Product Change Notification

INDUCTIVE COMPONENTS

May, 2009

Packaging Improvement for Model 70F Series

Old Box-Foam Packaging

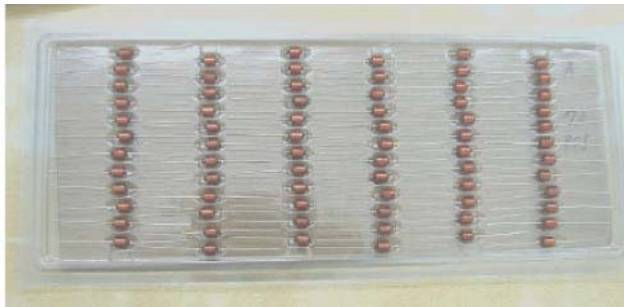
On May 6, 2009, the packaging method of selected part numbers in the [Model 70F series](#) was updated from box-foam to tray packaging as outlined below. The packaging upgrade provides better protection to components, minimizing damage during shipping.

Tray Packaging - part numbers with improved tray packaging and no change to MOQ/MULT quantities:

70Fxx1AF-RC
70Fxx2AF-RC
70Fxx3AF-RC

Tray Packaging - part numbers with improved tray packaging and a change to MOQ/MULT quantities:

New Tray Packaging
